**ROCK HARBOR COMMERCIAL WHARF IMPROVEMENTS
TOWNS OF ORLEANS, MA
ADDENDUM #3**

PROJECT: Rock Harbor Commercial Wharf Improvements

DATE: March 22, 2024

CONSULTING ENGINEER: Foth Infrastructure & Environment, LLC
15 Creek Road, Marion, MA 02738

DEMOLITION PLAN
2 OF 2

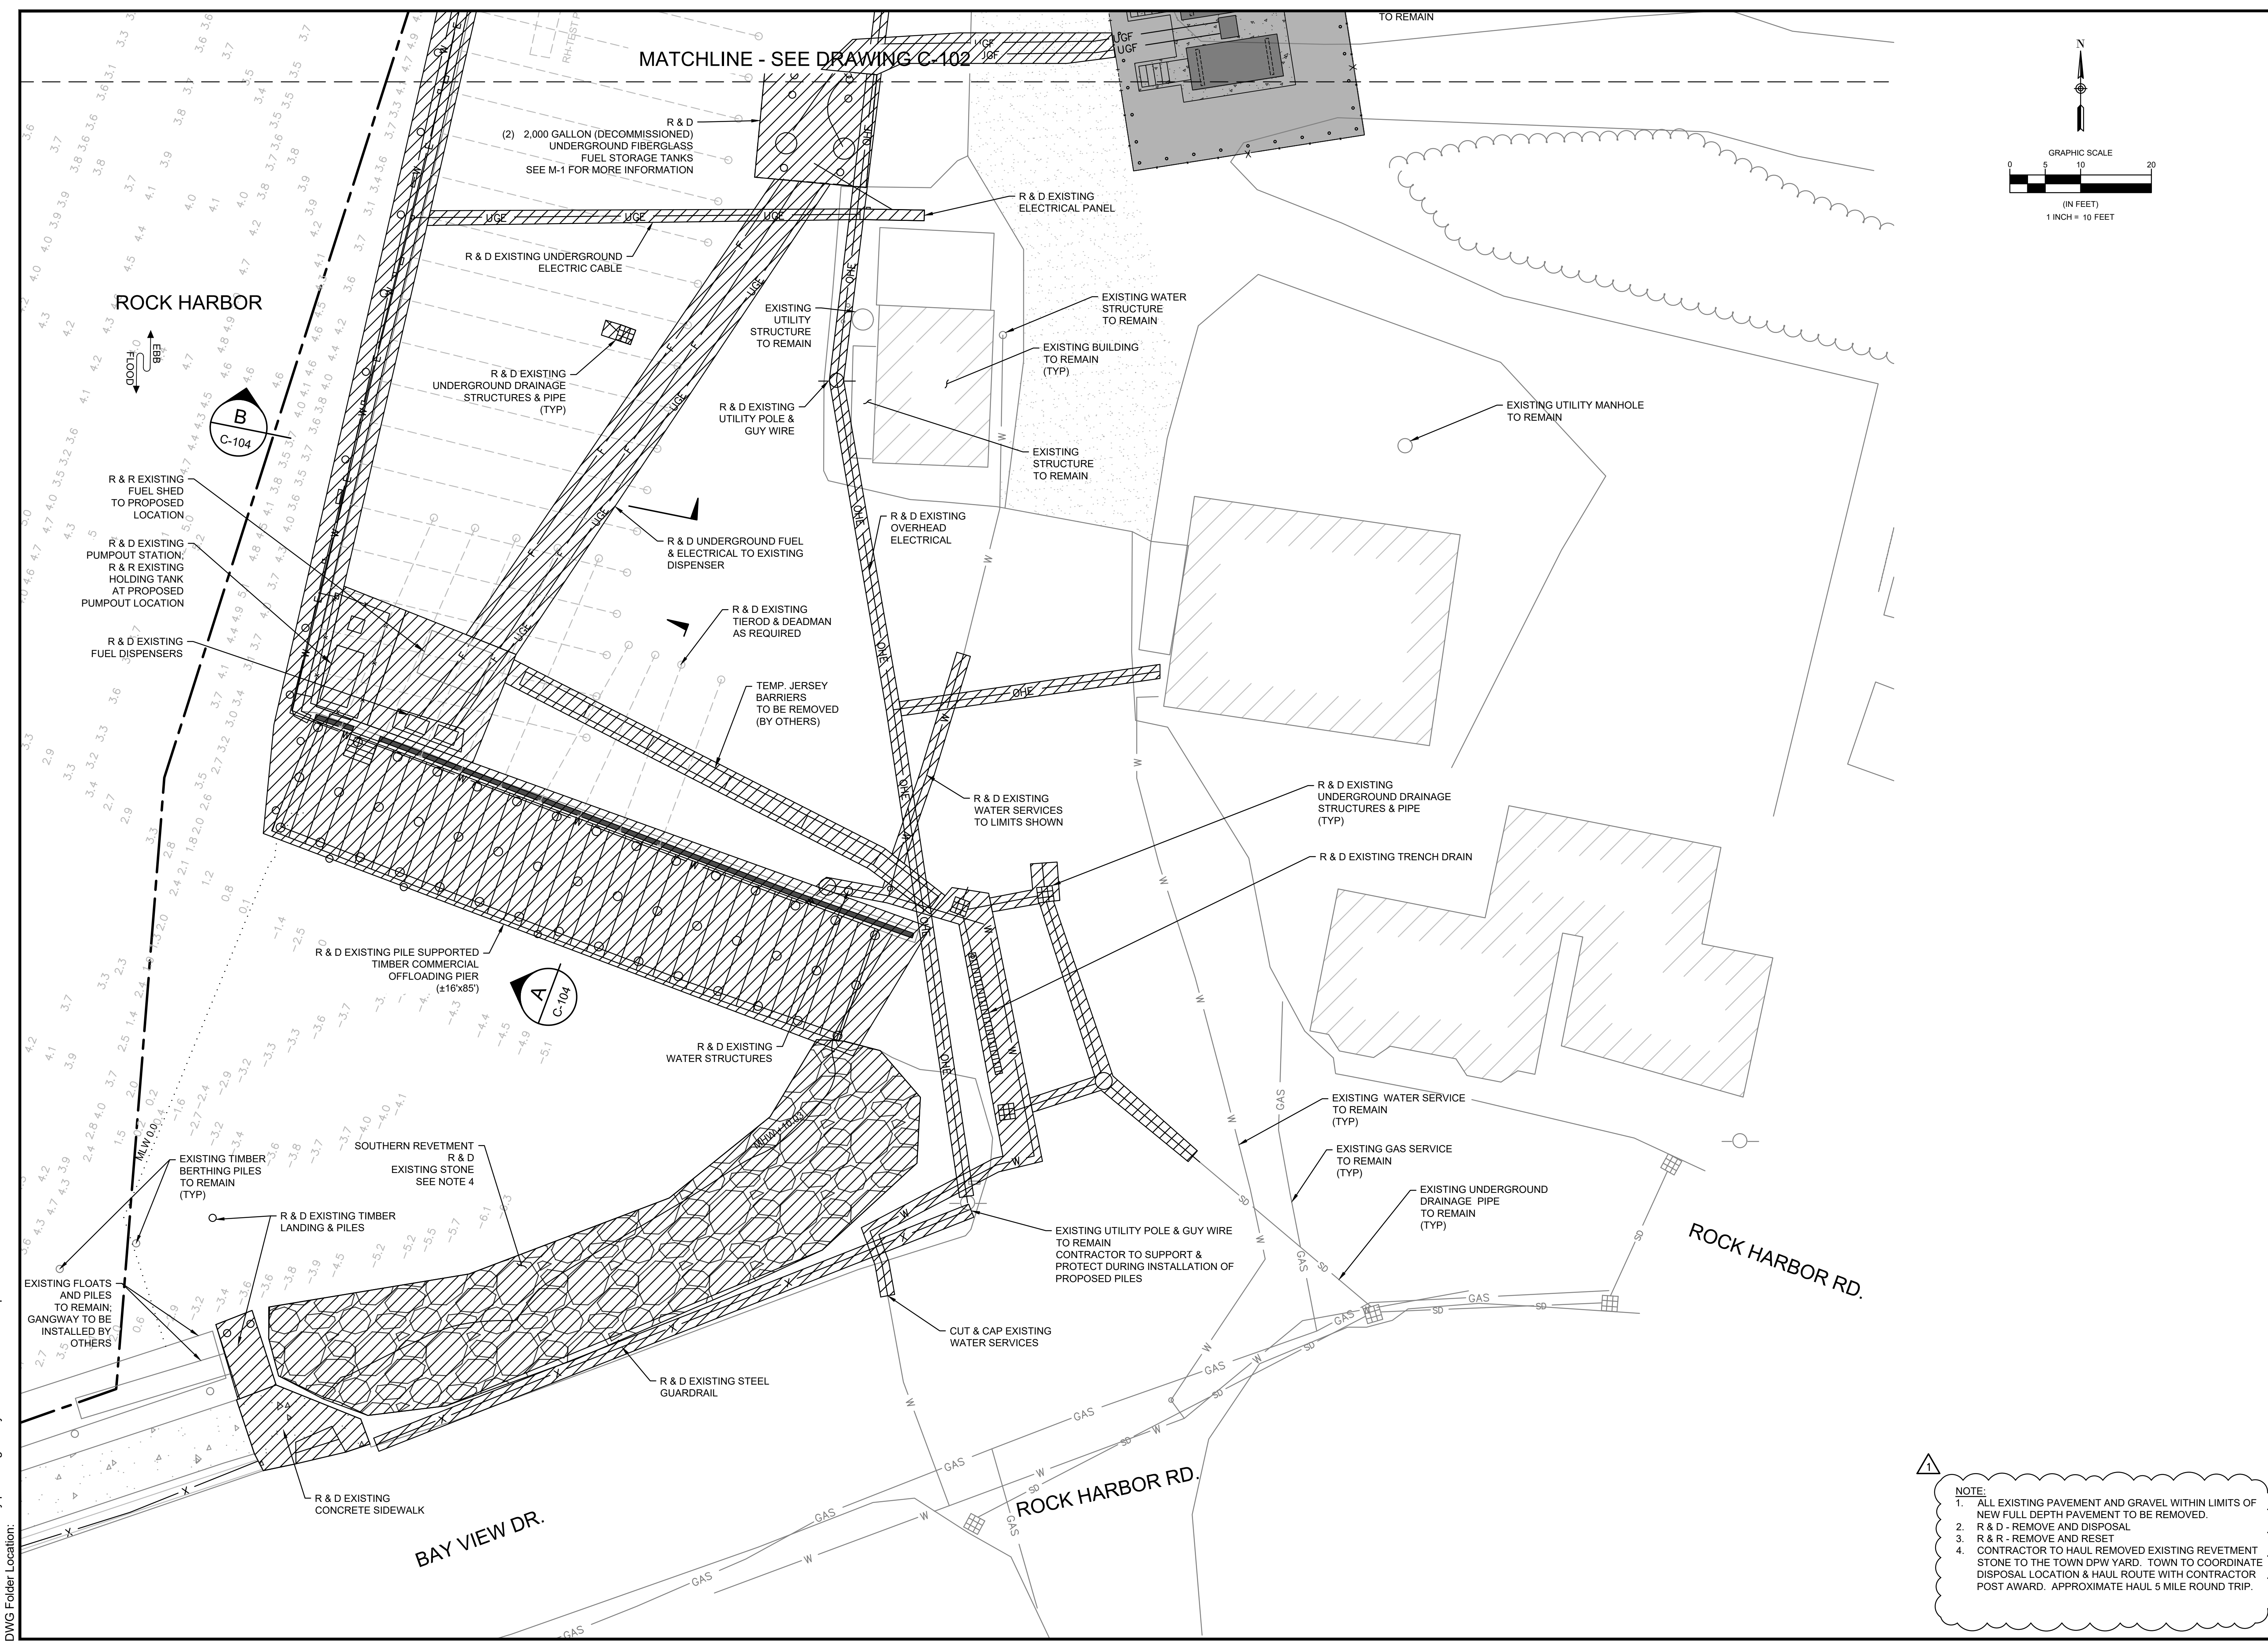
67. In reference to the removal, transport and setting of the South revetment stone to the North revetment, please provide a scope of work or details for the North revetment improvements so that Contractors can better understand that work as well as how much surplus revetment stone will need to be hauled offsite.

RESPONSE: All existing revetment stone shall be hauled to the Town yard. See call outs and notes on revised sheets C-102 and C-103 attached herein.

- ALL EXISTING PAVEMENT AND GRAVEL WITHIN LIMITS OF NEW FULL DEPTH PAVEMENT TO BE REMOVED.
- R & D - REMOVE AND DISPOSAL.
- R & R - REMOVE AND RESET.
- CONTRACTOR TO HAUL REMOVED EXISTING REVEMENT STONE TO THE TOWN DPW YARD. TOWN TO COORDINATE DISPOSAL LOCATION & HAUL ROUTE WITH CONTRACTOR POST AWARD. APPROXIMATE HAUL 5 MILE ROUND TRIP.

PROJECT NO: 00190004.10
SHEET NUMBER
C-204

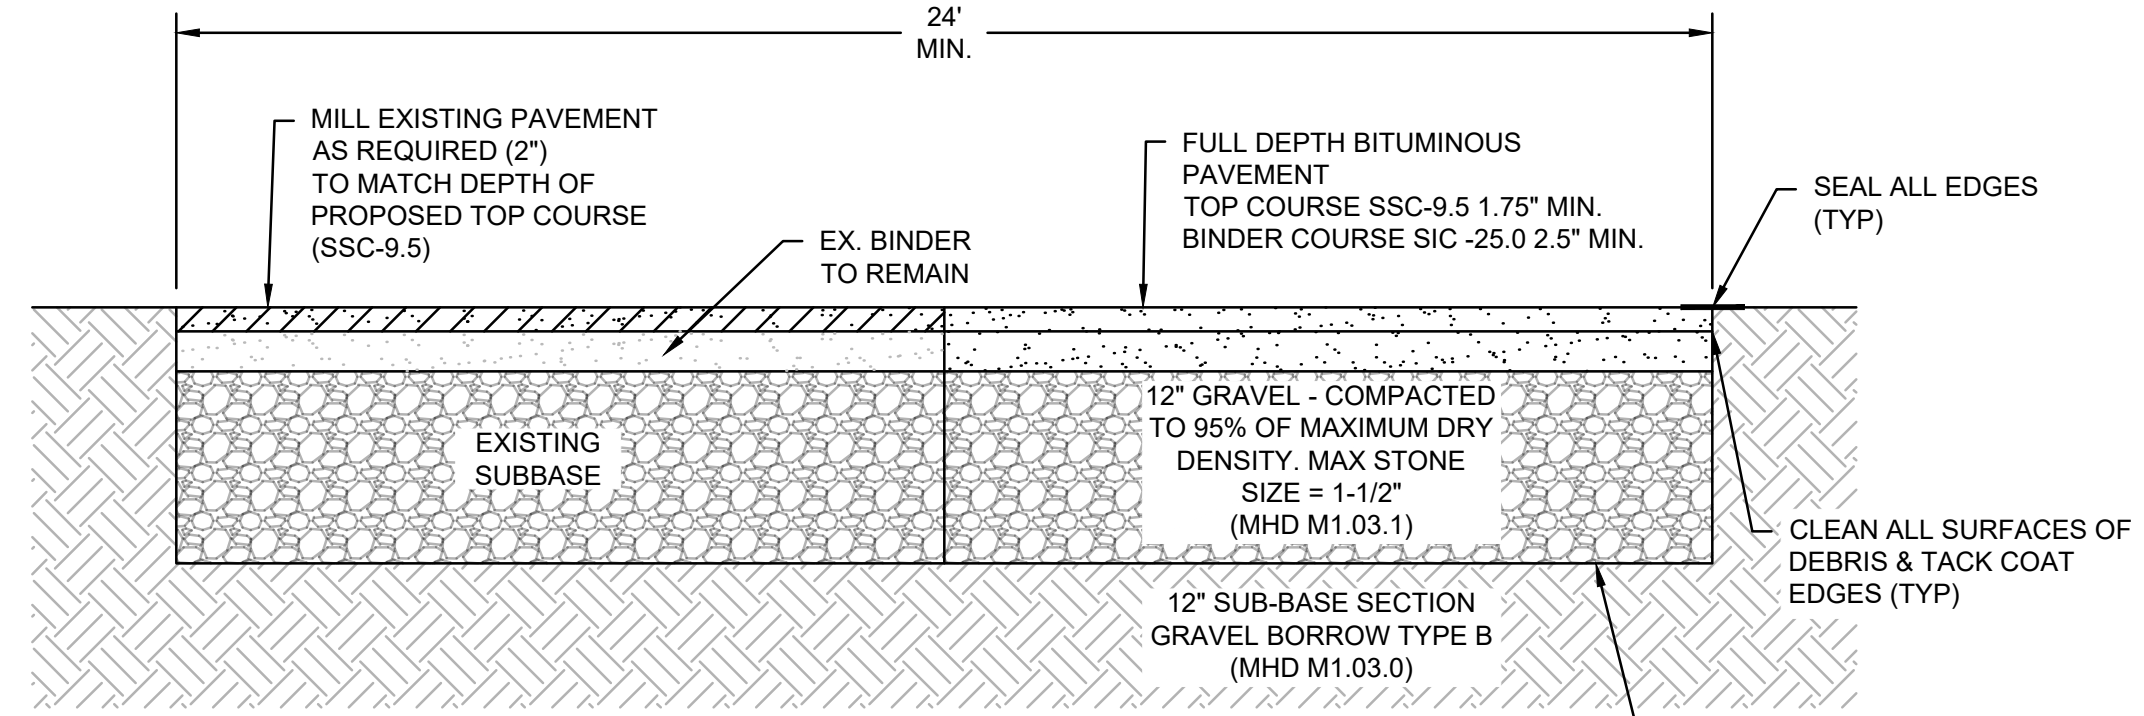
91. Some of the layout does not match up, Sheet 502 14-770’s show wrong dimension for the LF of wall.

RESPONSE: Length of sheet pile bulkhead has been corrected on C-204 and Unit Price Bid schedule. See attached C-204.
